State Significant Development Application - SSD 6092 Response to Submissions

Block 8, Central Park

Mixed Use Development

Submitted to Department of Planning and Environment
On Behalf of Central Park JVNo 2

Figure 3 – Typical single aspect apartment
Source: Smart Design Studio

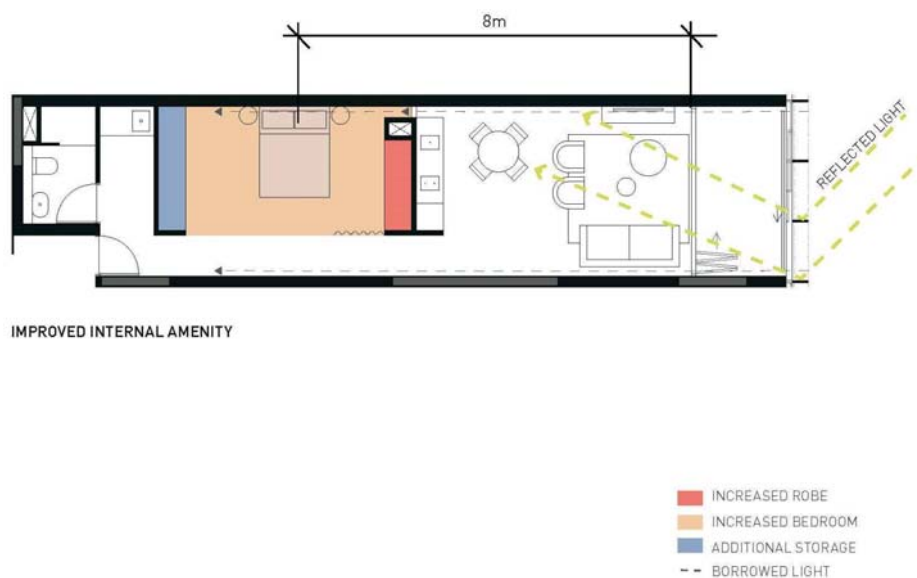
DP&I requested consideration be given to the 'Rules of Thumb' as contained in the Residential Flat Design Code. In particular, justification is to be provided in relation to apartment depths, depth to back of kitchens, access to cross ventilation and suitability of the proposed open space areas (including clarification of the design of loggias, and location of open space to apartments on the ground floor).

In accordance with the RFDC 'Rules of Thumb' single aspect apartments should be no more than 8m from a window. While the single aspect apartments within Block 8 exceed this requirement, their depth has been reduced on average to 10m,

and south facing single aspect apartments have been reduced on average from 14.5m to 14m deep in consideration of the amenity of occupants. The apartment layouts have also been amended to deliver additional amenity including:

- Increased storage;
- Borrowed light;
- Increased bedroom area; and
- Walk in robe.

A typical single aspect apartment is shown in **Figure 3** below.
